**Agenda
Planning Commission
Council Chambers
Wednesday, 16 October 2013 - 7:00 P.M.**

**Staff Review of Site Plan and
Planned Unit Development (PUD) rezoning
216 E. Michigan (proposed address) – southwest corner of
E. Michigan Ave and Park Street
Ypsilanti, Michigan**

Action Requested: Site plan approval; Rezone to Planned Unit Development (PUD)

Figure 3: Conceptual Site plan from Development Agreement

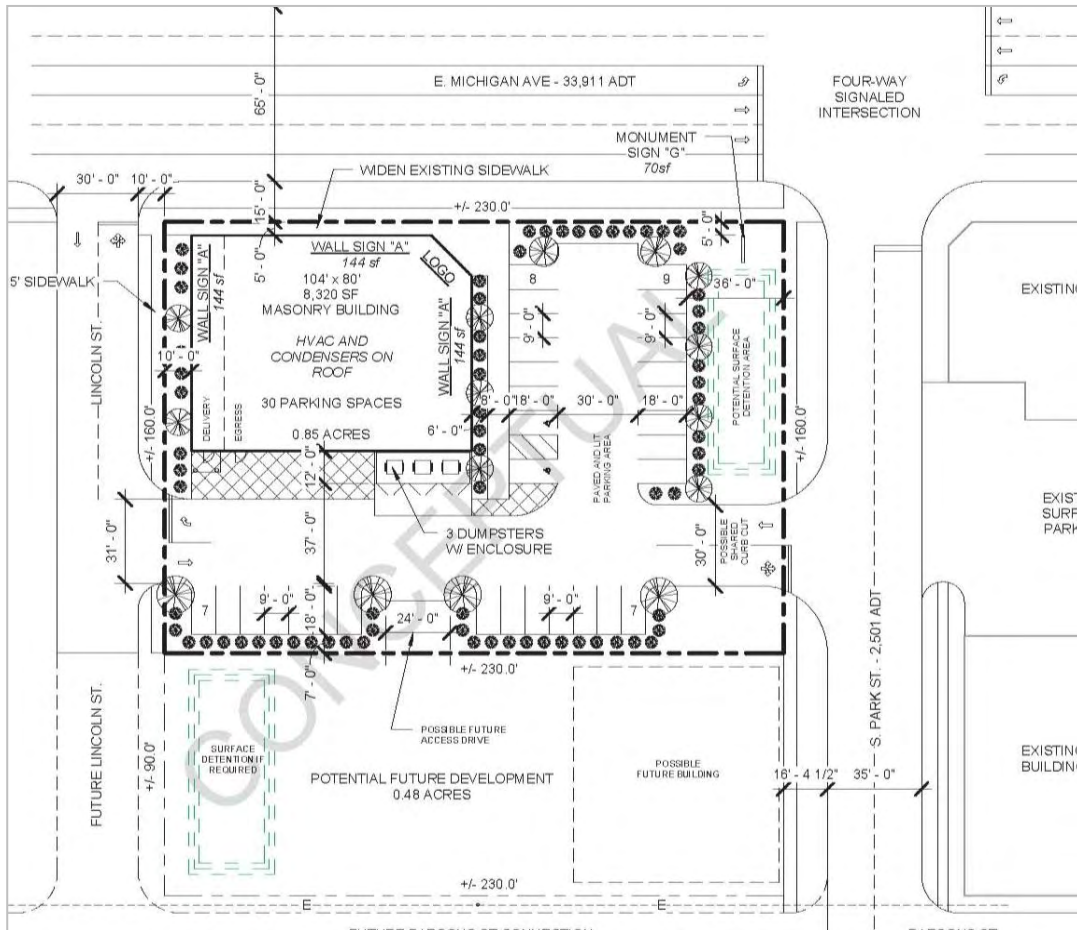
The parcel being created for the Family Dollar is based on maintaining the existing street grid created by Park St., Michigan Ave/ and the future S. Lincoln Street. Originally, building out Parsons Street was of interest to the City, but Core Resources determined they did not need the additional land. A revised scenario (below) shows that a separate buildable parcel can be created out of the land south of Family Dollar, but north of a proposed Parson Street extension west (see below). In this scenario, shared access to the curb cuts on the proposed Lincoln and Park Streets as well as an access drive to the south are necessary.

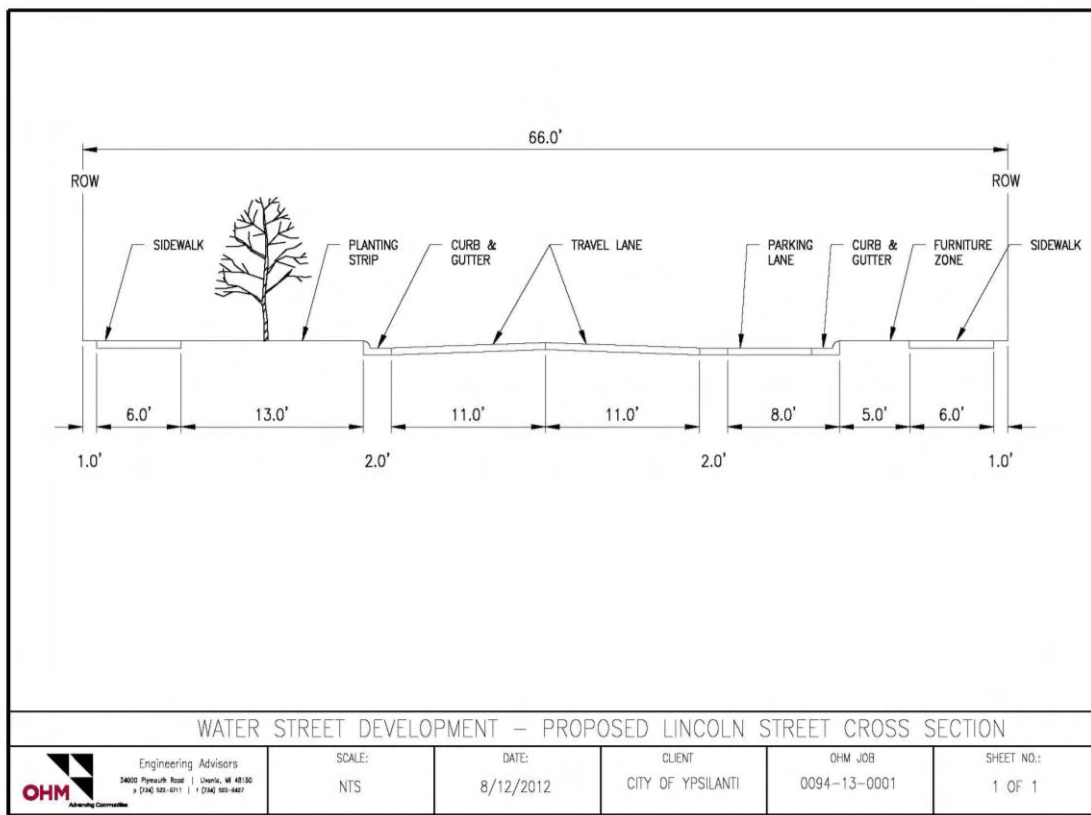
building entrance is located off Michigan Ave. and the parking lot to the east of the structure. Sidewalk is provided on Michigan, Park Street and the proposed Lincoln Street, including a walkway between the building and parking lot extending from Michigan Ave. south to the extent of the structure. An ADA ramp is provided between the barrier-free parking spaces in the parking lot, to the walkway. ADA ramps are also noted at the corner of Michigan and Park Street. The pedestrian crossing of Lincoln is expected to be flush with the curb/street. Three bike racks are provided near the building entrance on Michigan Ave. providing space for 6 bicycles.

Vehicular access is available from both Park and Lincoln Streets. The proposed site plan envisions a full movement intersection at Lincoln and Michigan Ave. as well as at the signalized intersection at Michigan Ave and Park Street. Vehicles can enter the drive at the rear of the building from both streets, with access to parking south and east of the building. The drive width is shown at 30 feet. The engineering letter from Sept. 13, 2013 notes that the drive and approach be reduced (see attached). A note has been provided that the drive as well as potential connection to the southern parcel will have an access easement. The maneuvering lane for the parking east of the building is 24 feet. Truck access is available from either street but is expected primarily from Park Street do to the signalized intersection. A loading area has been designated at the southwest side of the structure, and exceeds the 10 x 50 requirement

Items to be addressed:

1. Michigan Ave. 10 foot sidewalk should extend to Lincoln Street
2. Move "tags" on site plan to match relocation of barrier-free parking and ramp
3. Reduce aisle and approach radii per Engineering Letter dated 9-13-2013

2 LINCOLN STREET ELEVATION

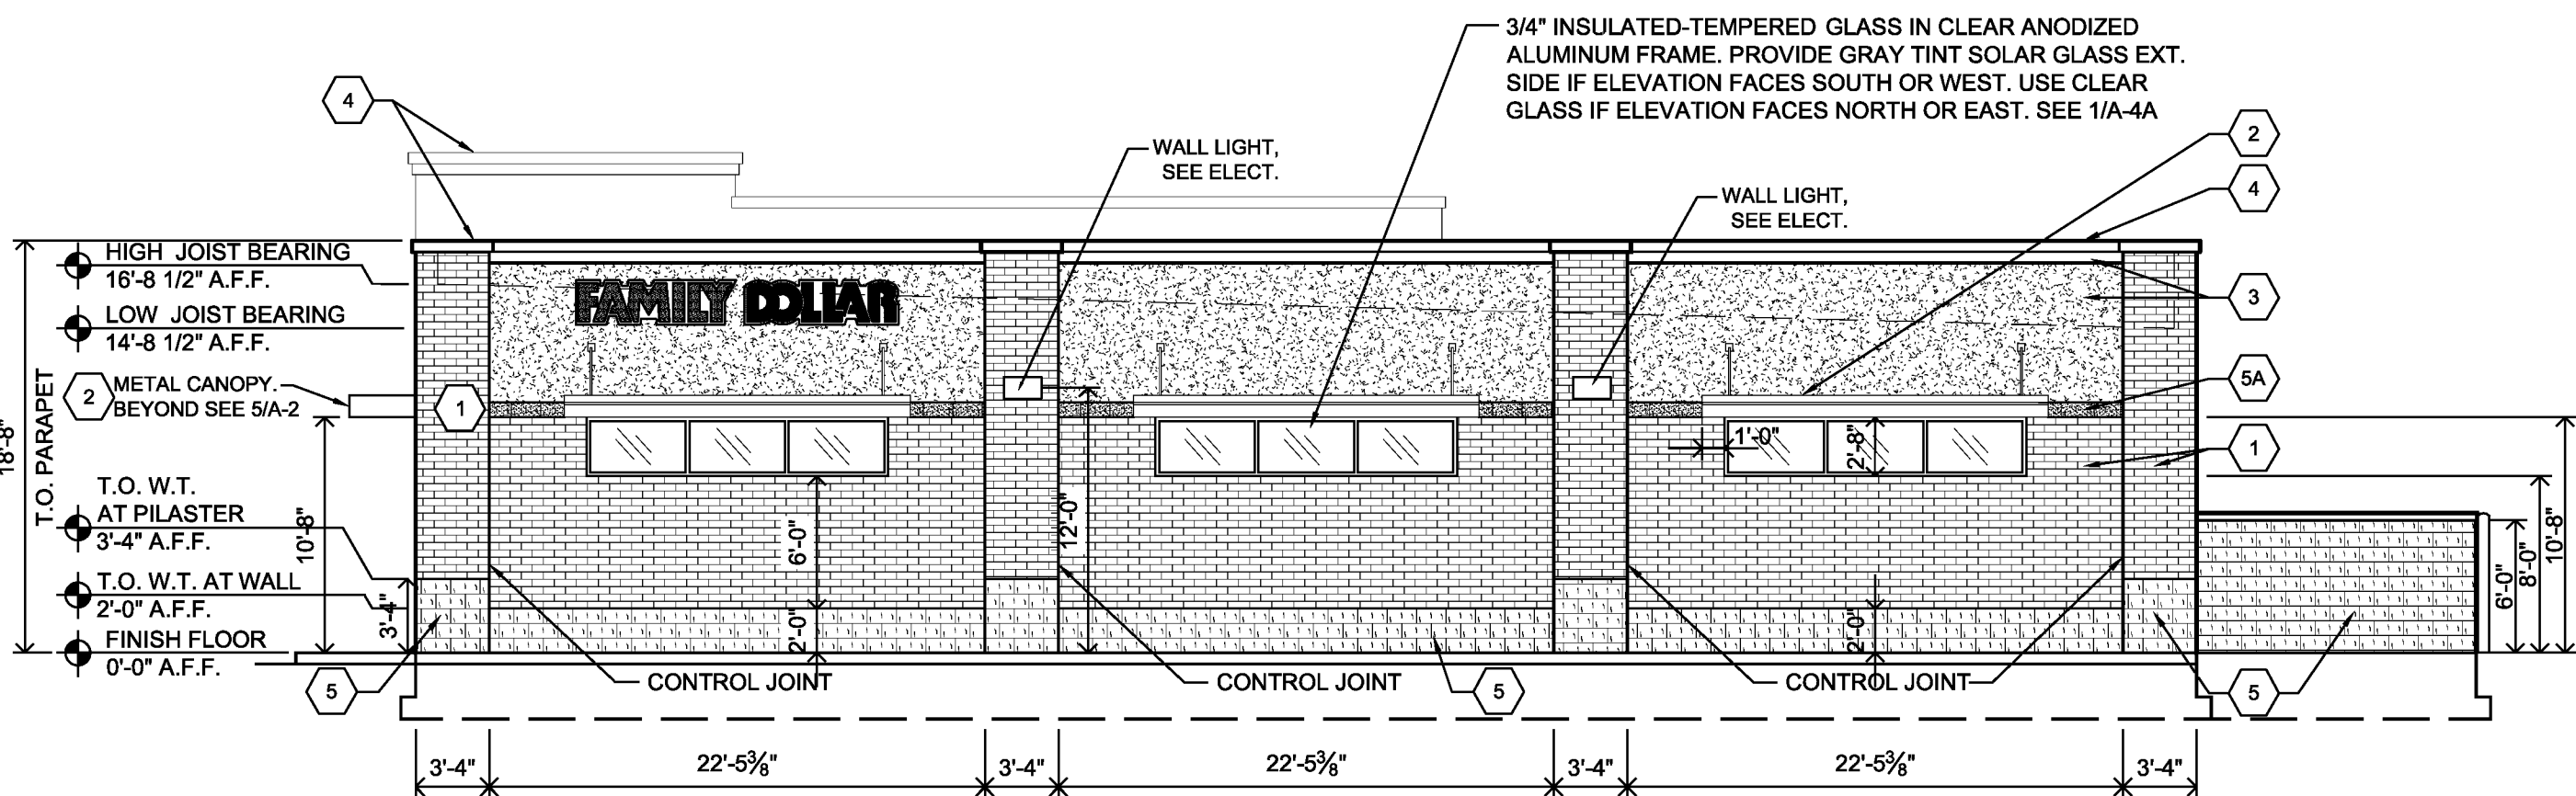
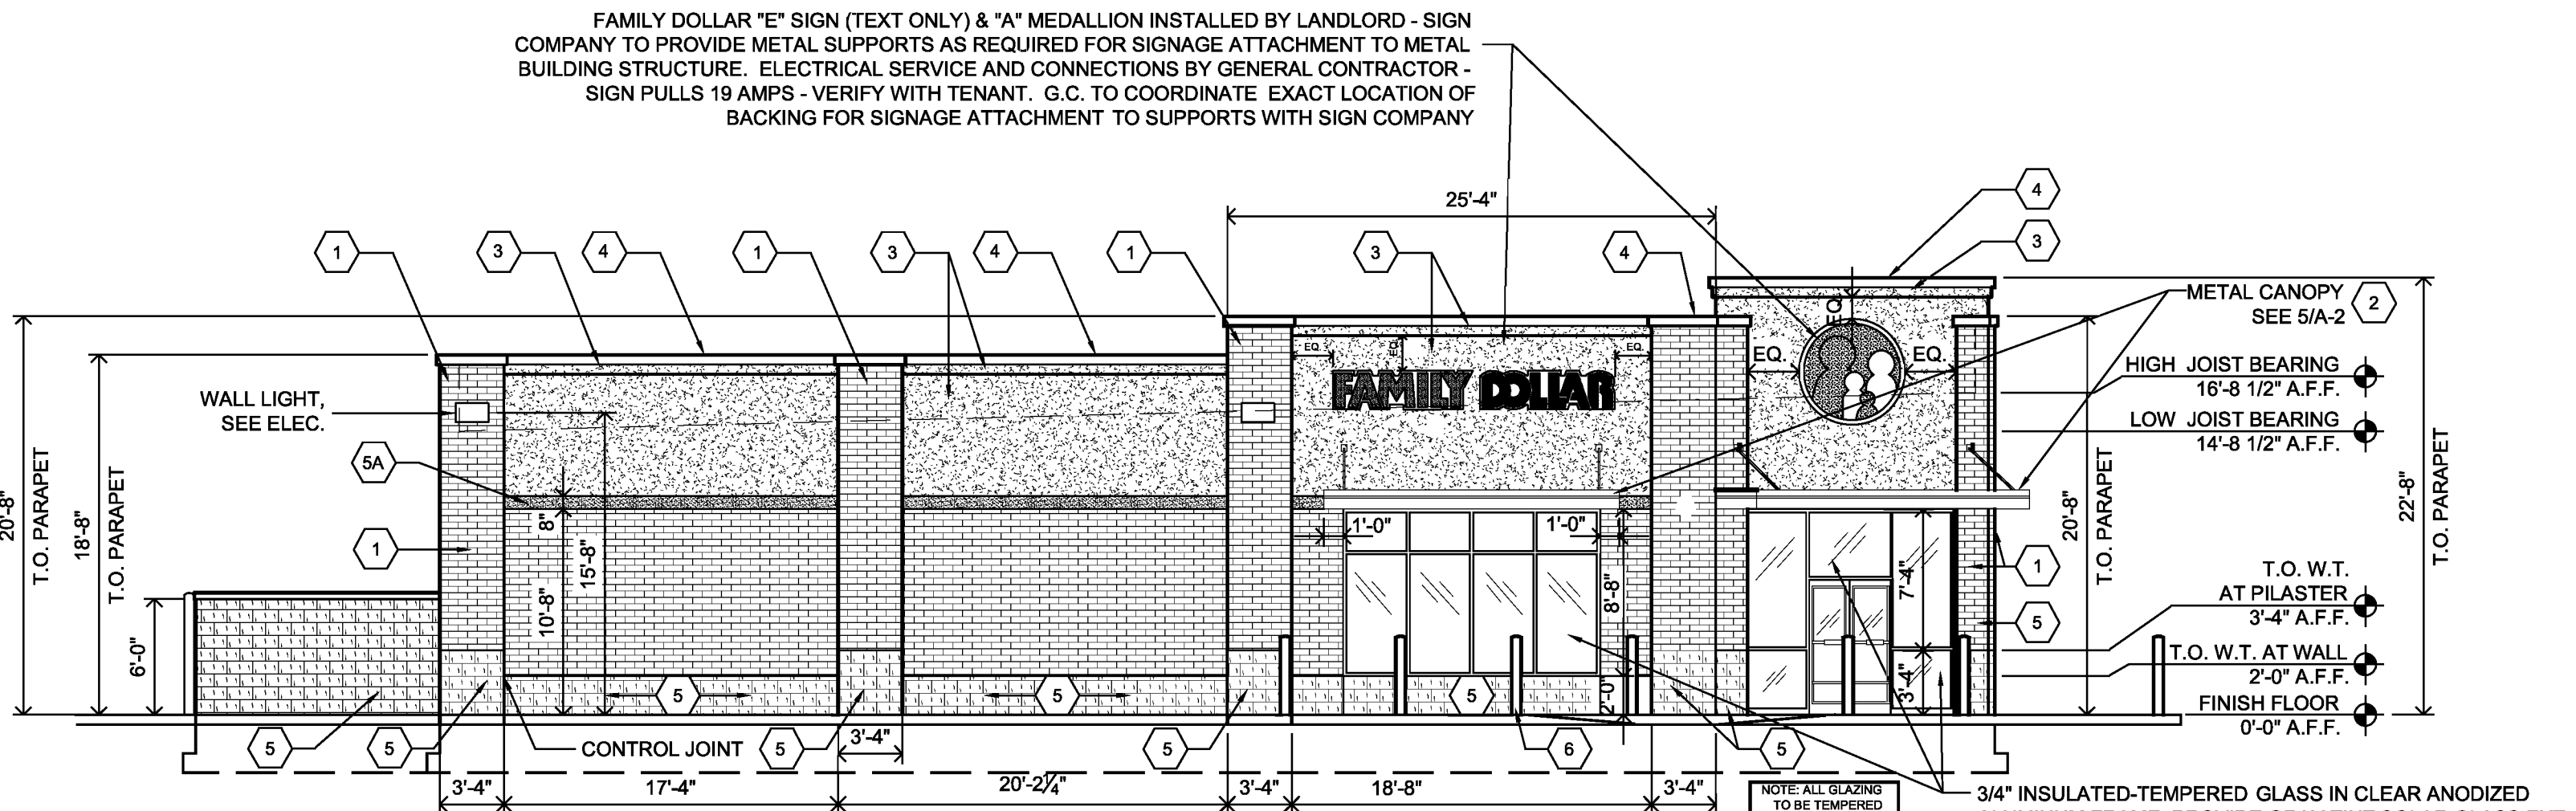
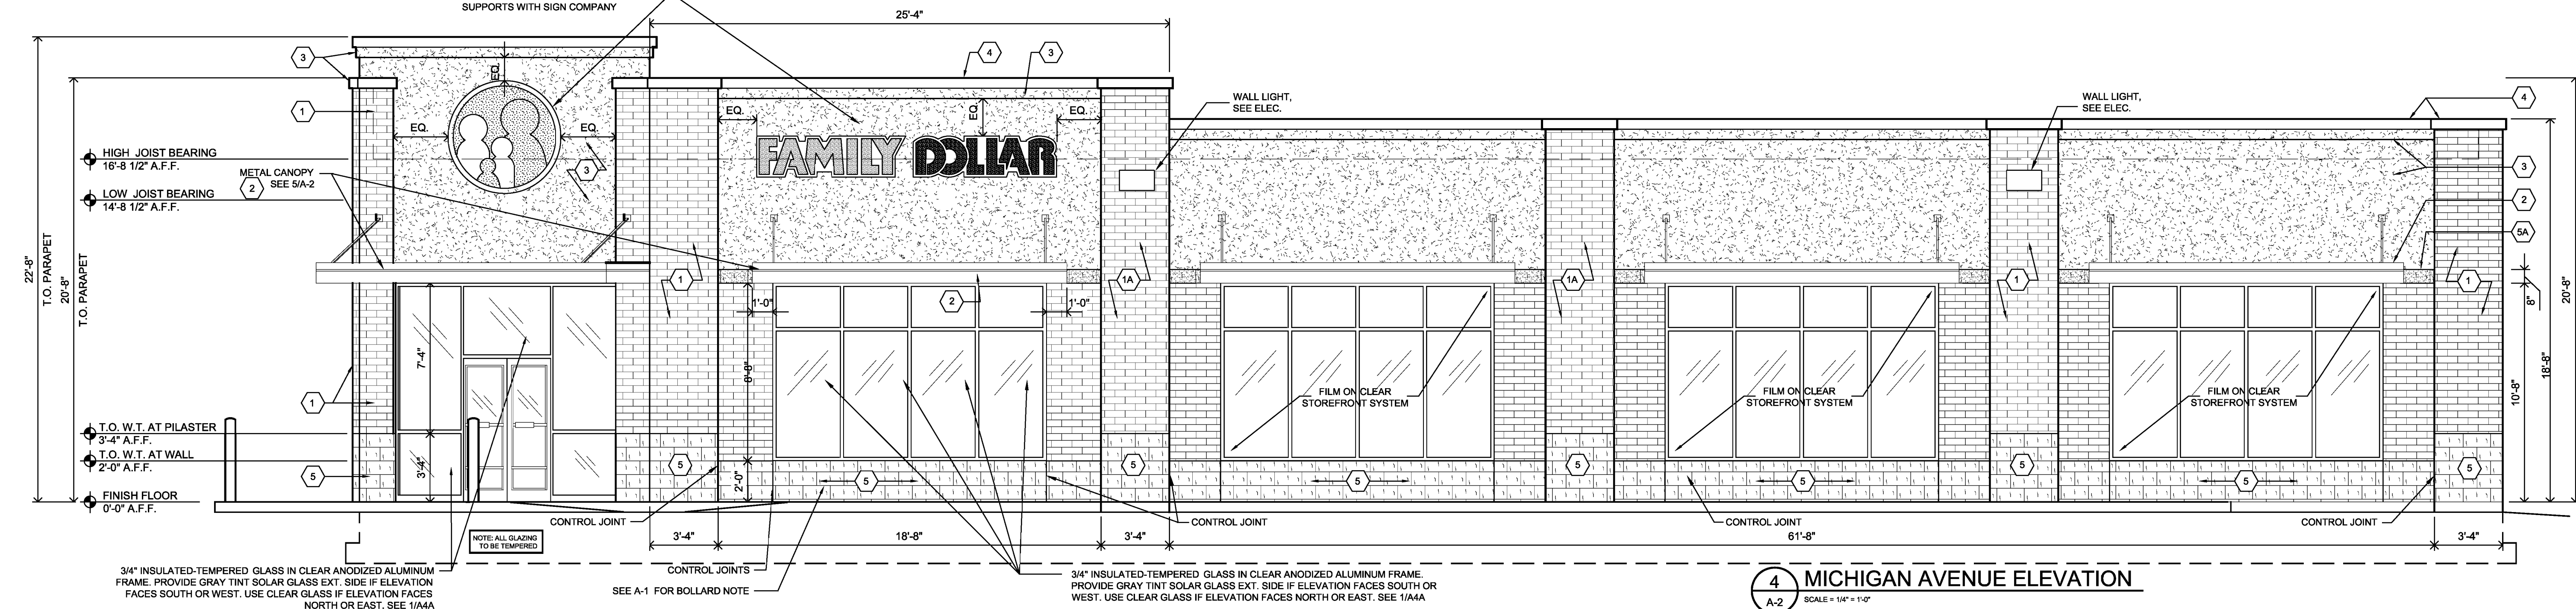
The proposed Family Dollar building will be oriented toward the corner of Lincoln and Michigan Ave, with the length of the building along the Michigan Avenue frontage. Sets of windows 8'8" in height repeat along the Michigan Avenue frontage. Three banks of smaller windows grouped in threes 2 1/8' tall and tinted gray have been added along the Lincoln Street frontage. The entrance is located at the corner of Michigan Ave and the parking lot.

- 1. Remove tinting from Lincoln Street windows.*

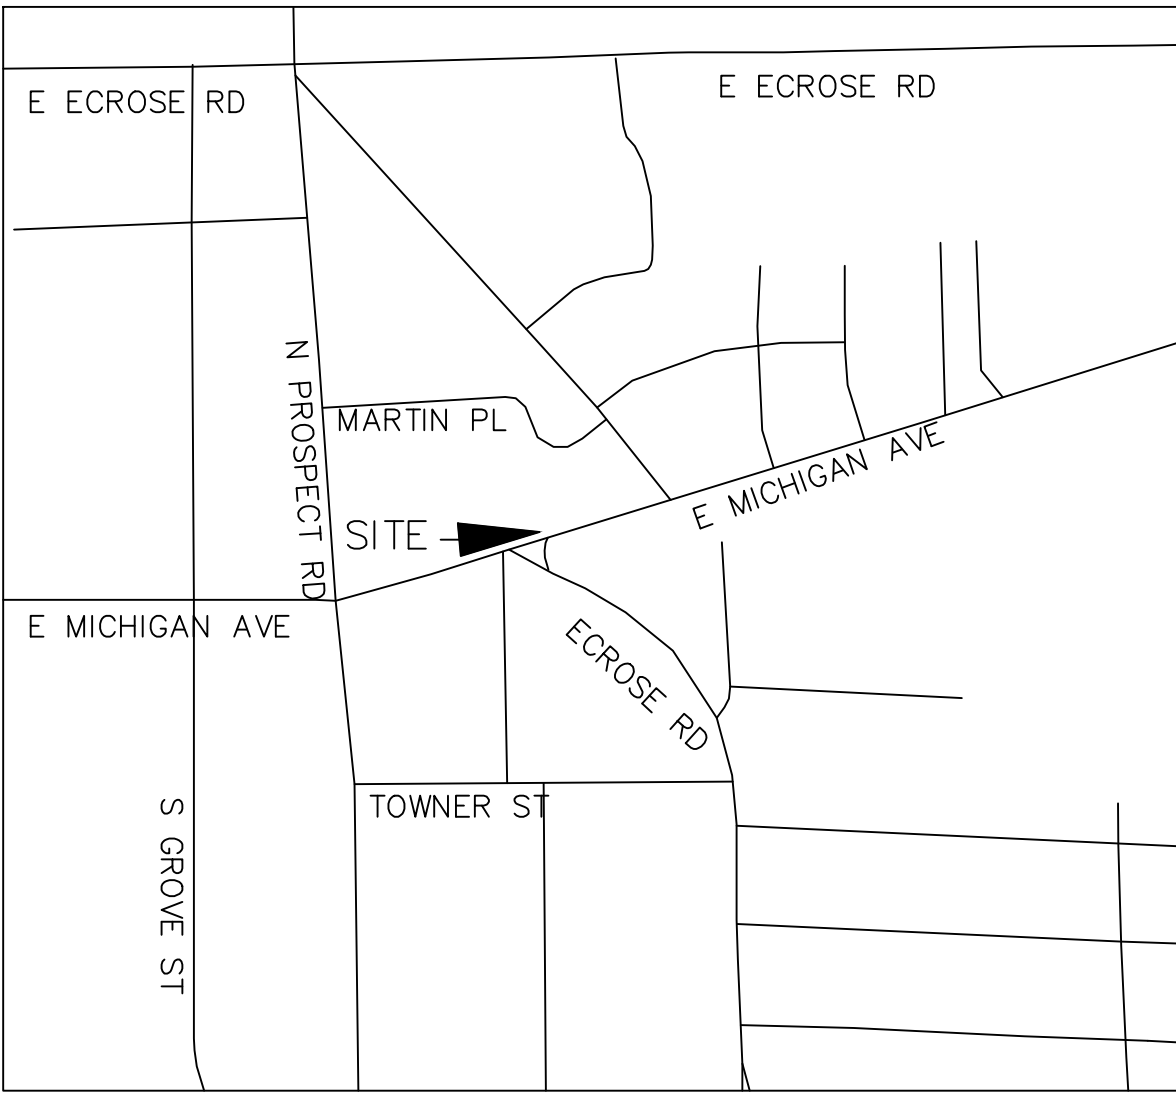
1. Provide a complete landscape plan that conforms with the landscaping ordinance, in particular the minimum area requirements, greenbelt dimensions and layout, and parking layout. Ensure it addresses all other issues raised in this review.

2. Eliminate the three parallel and three perpendicular spaces adjacent to the frontage; meet the requirements of 122-704, and ensure that garbage trucks have a clear path of entry and exit from the site.
